Access Compliance Report

Public Rights-of-Way

Intersection ID: 12365	Main Street: E_10TH_ST	Cross Street: N_ALEXANDER_ST	Location: W
ADA ID: 37FDDED512A3	Ramp Type: PerpDiag	Initial Pass/Fail: Fail	Overall Compliance: No
Severity Score: 22.5			
Codes/Mitigation Info/Possible Solution		Field Measurements/Component Compliance

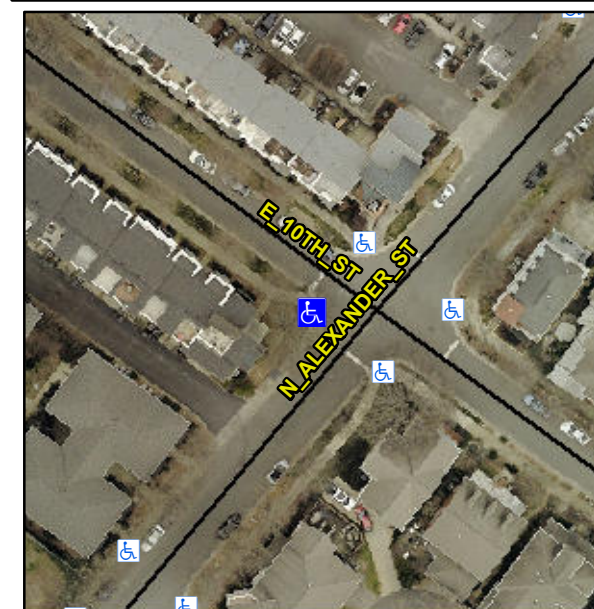
Not Found, R304.5.1, R304.2.2, R304.5.3

Compliance	Description	Data	Compliance	Description	Data
N/A	Ramp Length (in)	27.0	No	Ramp Slope (%)	9.4
No	Ramp Width (in)	46.0	No	Ramp XSlope (%)	3.3
N/A	Flare Type LT	N/A	N/A	Flare Type RT	N/A
N/A	Flare Slope LT (%)	N/A	N/A	Flare Slope RT (%)	N/A
N/A	Flare Traversable LT?	N/A	N/A	Flare Traversable RT?	N/A
N/A	Landing Length (in)	N/A	N/A	DWS Provided?	N/A
N/A	Landing Width (in)	N/A	N/A	DWS Contrast?	N/A
N/A	Landing Slope (%)	N/A	N/A	DWS Length (in)	N/A
N/A	Landing X Slope (%)	N/A	N/A	DWS Full Width?	N/A
N/A	Landing Curb? (Y/N)	N/A	N/A	DWS Offset (in)	N/A
N/A	Shared Landing?	N/A			
N/A	Gutter Ponding?	N/A	N/A	Gutter Slope (%)	N/A
N/A	Gutter Lip Ht (in)	N/A	N/A	Gutter X Slope (%)	N/A
N/A	Painted X Walk1?	No	N/A	Painted X Walk2?	No
	X Walk 1 Direction	To SE		X Walk 2 Direction	To NE
N/A	X Walk 1 Width (in)	N/A	N/A	X Walk 2 Width (in)	N/A
	X Walk 1 Slope (%)	4.1		X Walk 2 Slope (%)	2.9
	X Walk 1 X Slope (%)	0.0		X Walk 2 X Slope (%)	5.1

Remove & Replace Curb Ramp With Two New Directional Ramps or Equivalent.
